APPLICATION FOR PERMIT TO DRILL, RE-ENTER, DEEPEN, PLUGBACK, OR ADD A ZONE

¹ Operator Name and Address Approach Operating, LLC 6500 West Freeway, Suite 800 Fort Worth, TX 76116		² OGRID Number 248343
³ Property Code 37929	³ Property Name Jerry Barela	³ API Number 30 - 39-30855
⁹ Proposed Pool 1 WC; Mancos		¹⁰ Proposed Pool 2

APPROACH OPERATING, LLC
OPERATIONS PLAN
BARELA NO. 1

WC Tierra Amarillo Mancos Conditions of Approval

Generic Well Schematic

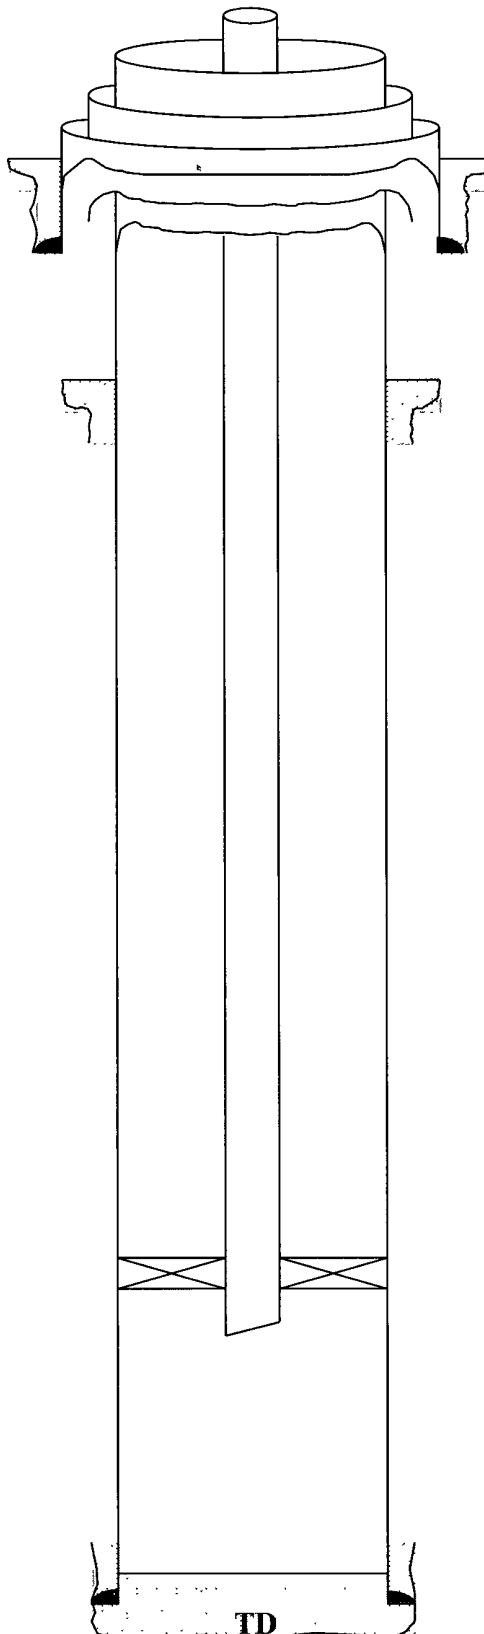
Cement volume for the production casing appears to be inadequate to circulate to surface. Please include enough cement to circulate hole, plus 50% excess. If cement does not circulate, a CBL will be required to show cement top and quality prior to completion.
